AMENDMENT NO. 4

Dated: 9/17/19

**Proposal for: Philadelphia Zoo Animal Hospital and Small Primate Holding
Mechanical Upgrades**

Project No.: 71-19-4365-01

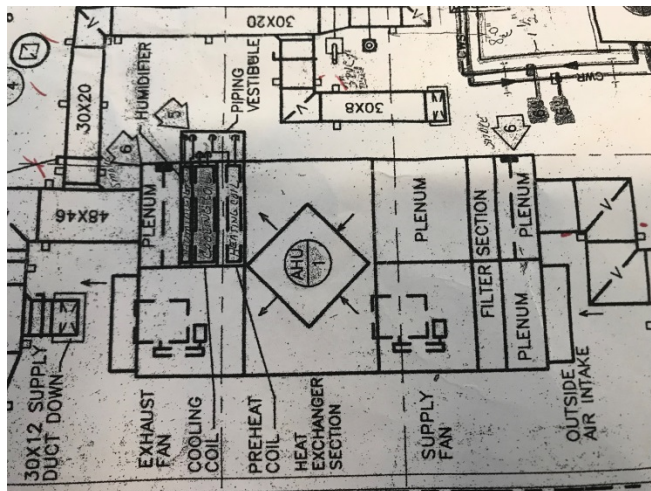
This contract requirement addition is for work to the existing AHU-1 (Custom HRU) that was not part of the original contract requirements.

Add the following note to Specification Section 230000 "SUMMARY OF WORK" Paragraph 1.3- subparagraph "B" section "3" subsection "I" as follows:

- I. Existing Roof Top Unit AHU-1. There is an existing roof top unit "AHU-1" on the roof as noted on Contract Drawing M1.0 Detail #1. This unit is a custom Raycan HRU (Heat Recovery Unit) with a 16,740 cfm supply and 13,810 cfm relief. This unit serves the hospital direct. The following are added contract requirements for this unit of which was not originally in the contract.*

1. **Chilled Water Coil Replacement AHU-1**

There is a 1,292.7 MBH Cooling Coil (575.4 Sensible, 256.8 gpm, 10 degree temperature rise (45-55), 6 row, 15.9 ft pressure drop). 16740 cfm, air pressure drop .58"WG, face velocity 385 fpm, 83.5DB/75WB incoming to 55.8DB/52WB. (4" chilled water supply and return). No apparent turbulators. Contract requirements shall be to isolate the chilled water coil in this unit and replace it. Recover the removed liquid (30% Glycol) for future re-use.

Approximate coil size (86"x72"-6 row). Contractor to verify on site of actual physical size of coil and actual connection sizes. Contractor responsible for opening AHU-1 removing and installing the coil with all required supply and return connections, testing and repairing leaks

Once the coil is replaced, Provide and install new 4" isolation valves (Durachoice VBB01GHD) on both the chilled water supply and return piping below the roof deck. Also provide and install (1) Watts model FV-4M1- 3/4 at the top of the return and supply manifold top cap (total of 2). This to include a tap and sea at the top of the manifold. Once the vents are installed; refill the coil and energize the coil by enabling a chilled water pump. Run for a period of 30 minutes on pump power only. Check for leaks and report to engineer/architect upon completion.

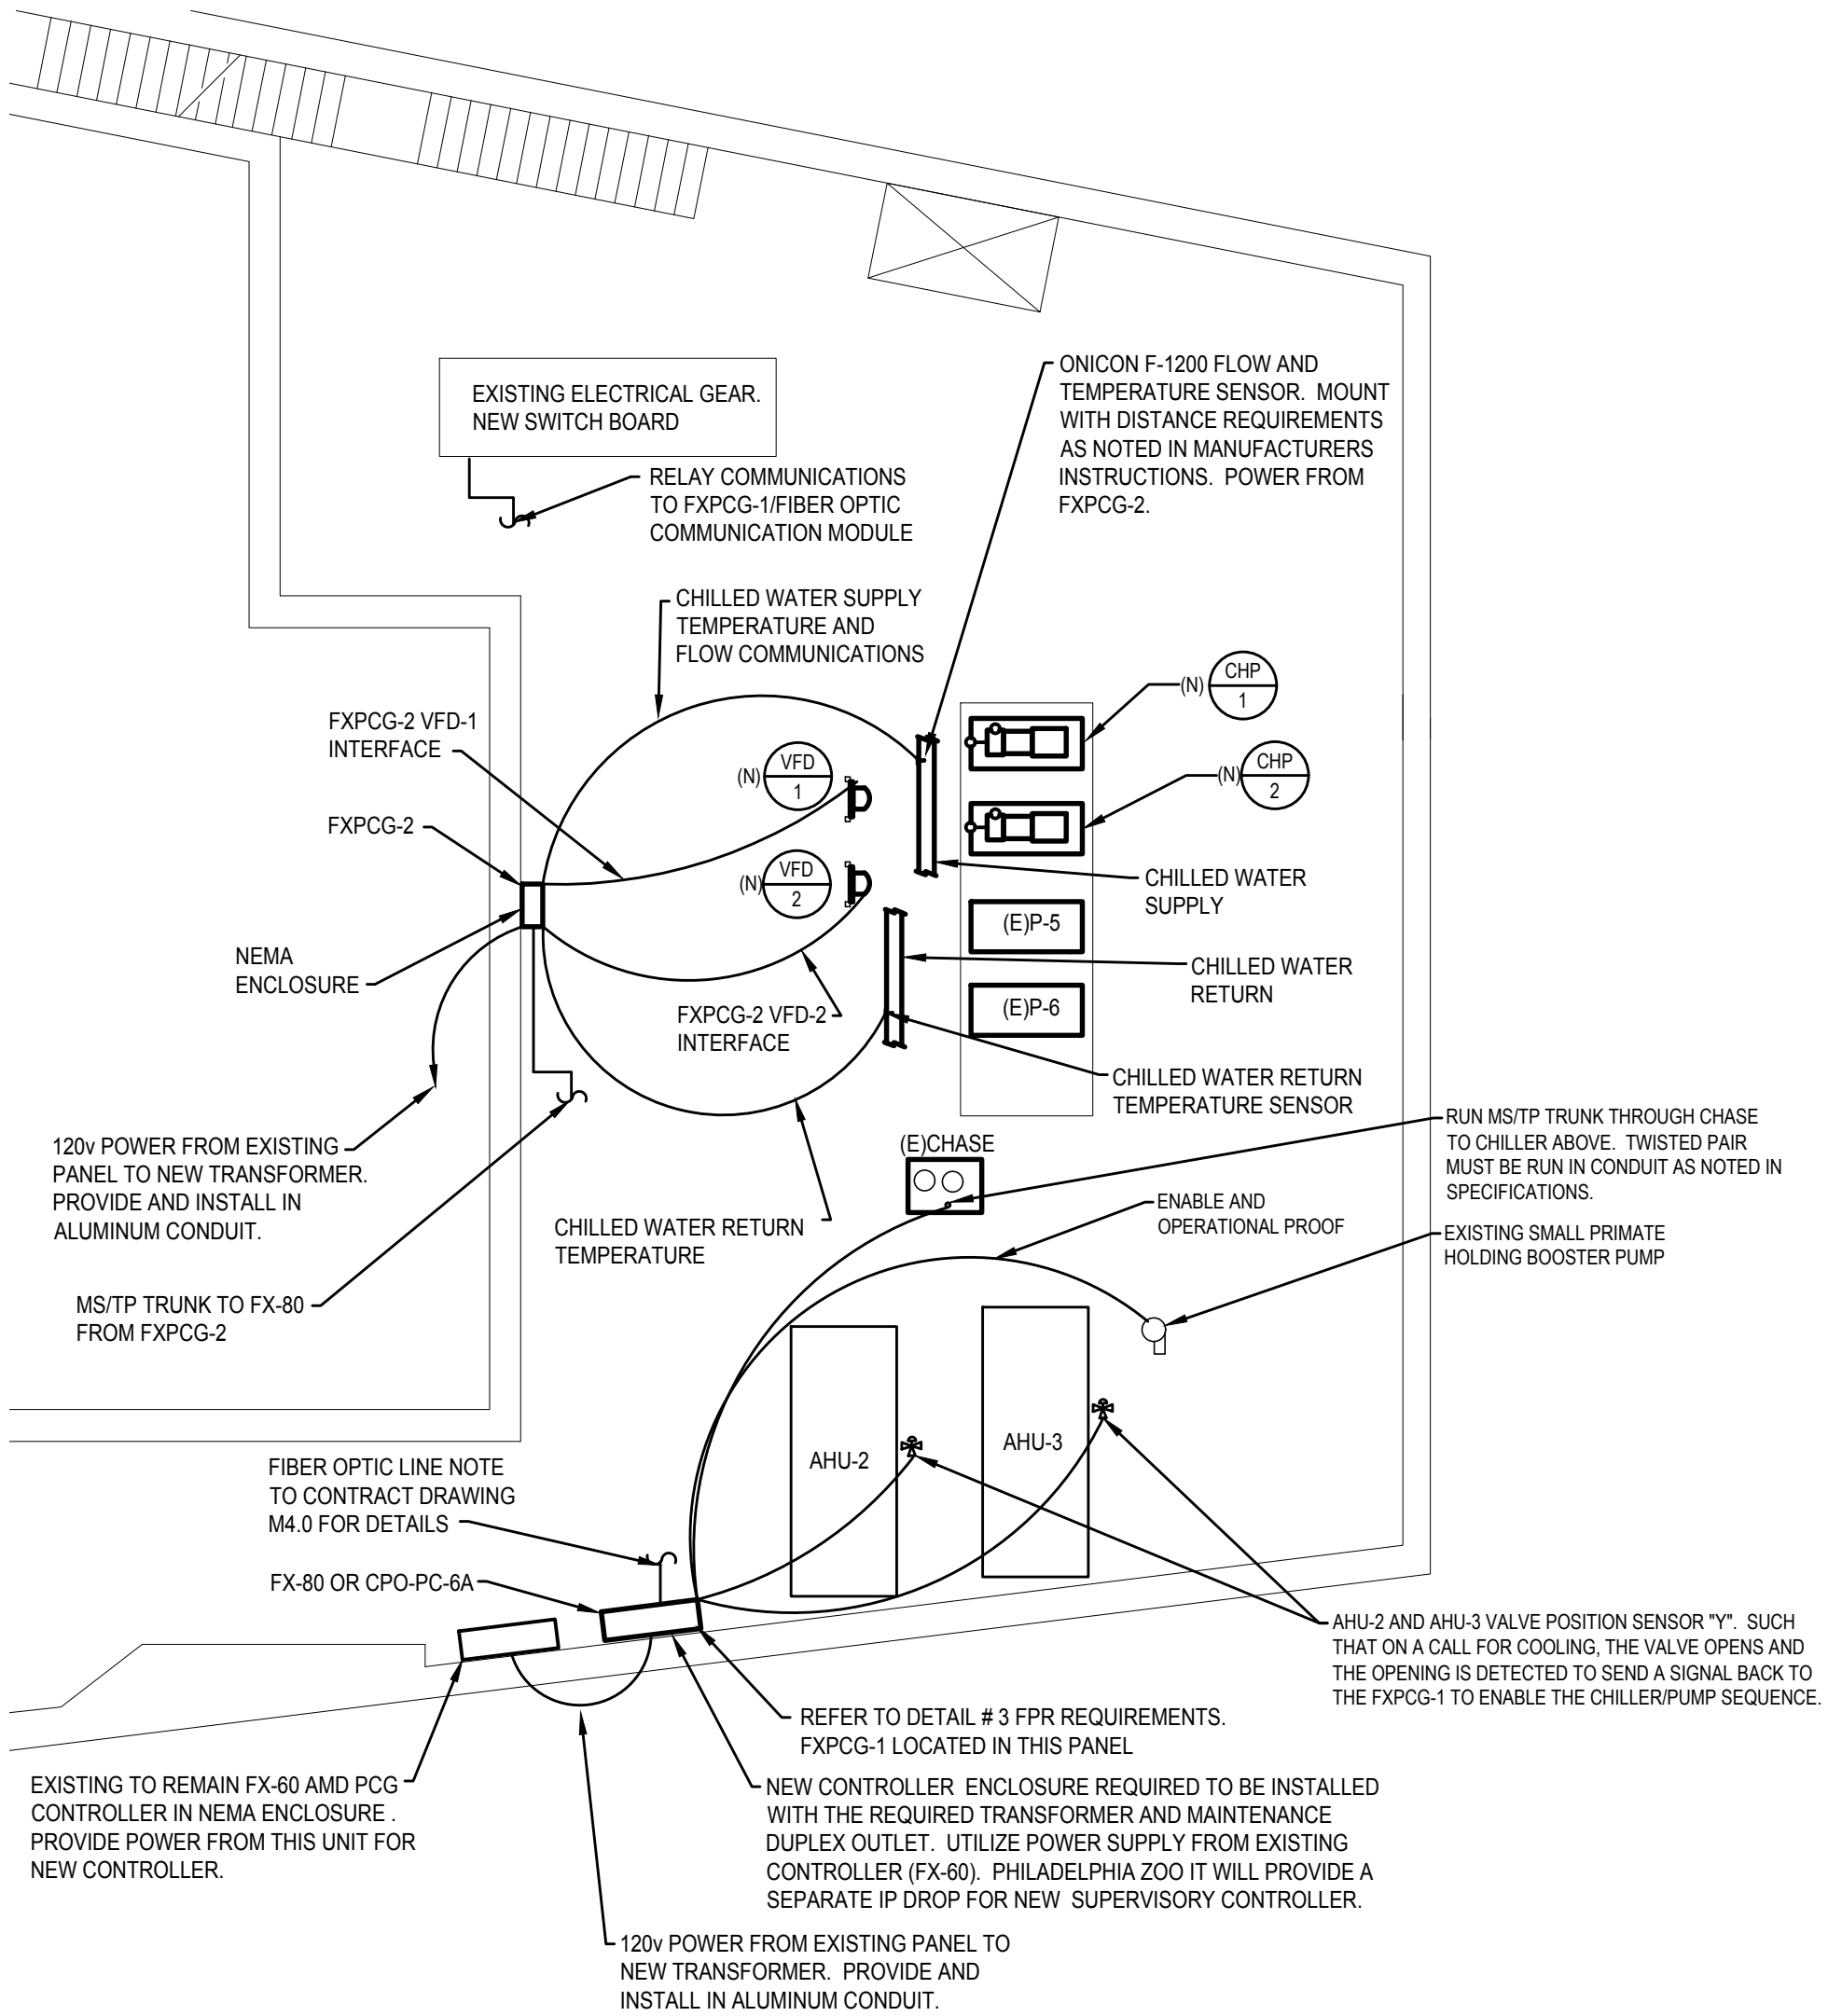
2. **New 3-way valves/actuators for AHU-1 chilled and hot water.**

This same existing HRU (AHU-1) has (2) 3-way control valves as follows (Verify in field-These are in the ceiling space of the washer/dryer room that is accessed through the OR Procedures Room. The ceiling in this room is a drop ceiling.:

- a. 3" Chilled Water: (256.8 gpm)
- b. 1.25" Hot Water: (15.3 gpm)

The existing valve actuators are Johnson Controls VA-7152-1001 proportional, 0 to 10VDC) with the 1900 conduit adapter kit. There is a (3") 3-way control diverting valve for the chilled water and a (1.25") hot water 3-way control diverting valve for the hot water. Contract requirements are the replacement of both valves and actuators utilizing the same signal from the existing Johnson Controls PLC (0 to 10Vdc). Note: there shall be a certain amount of discovery. Include in the bid the time to investigate the valves to assure connections. HRU Controls must be tested operational through existing PLC once valve replacement is complete. It is the contractor's responsibility to assure the valves cycle through the existing PLC command structure as they do currently. Replacement equipment shall be either Honeywell or Johnson Controls Products and shall communicate directly with the existing controller through the existing power and communication cabling. It is the contractor's requirement to isolate, drain, refill and test the new valves operational.

1
SKM1.0

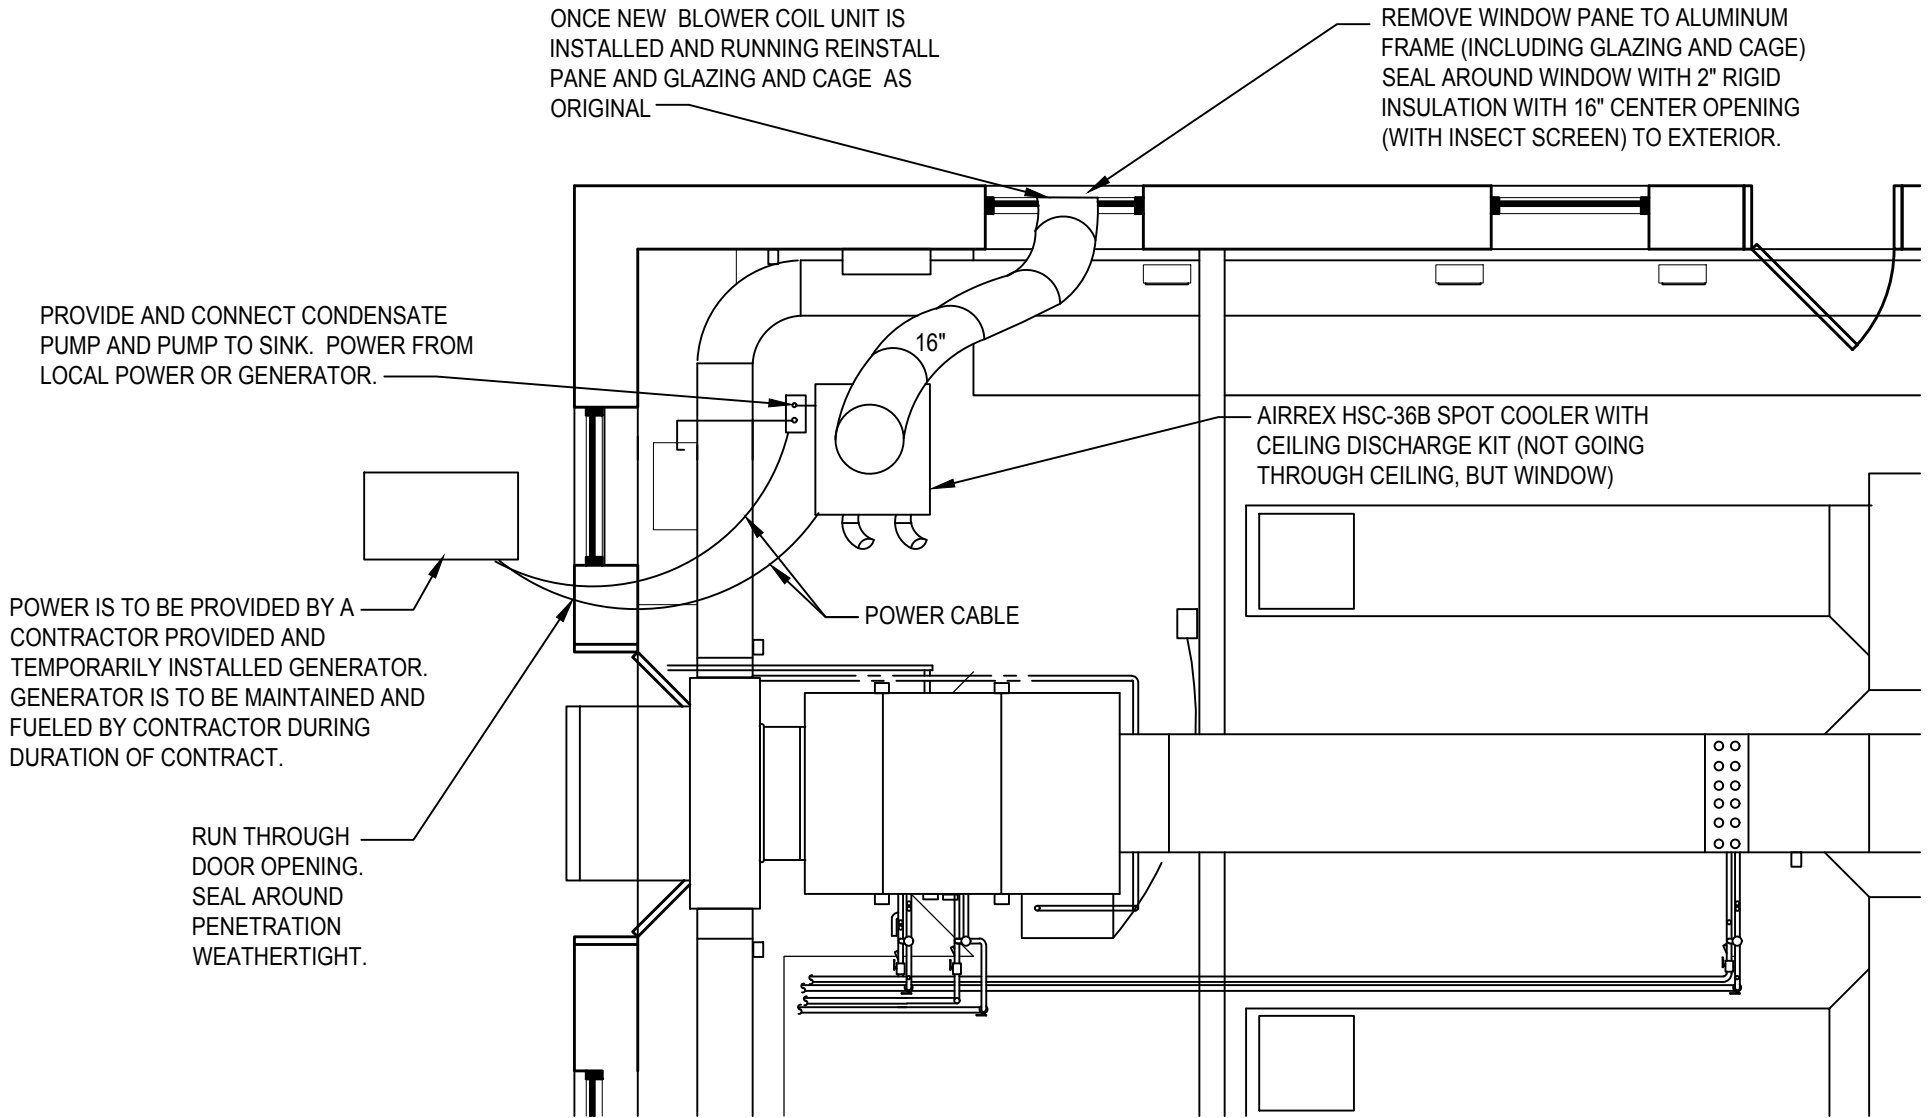
4. Philadelphia Zoo Small Primate Holding Mechanical Upgrades: Add the attached sketch SKM1.0. This sketch indicates the temporary cooling requirements for the Small Primate Holding building during construction.
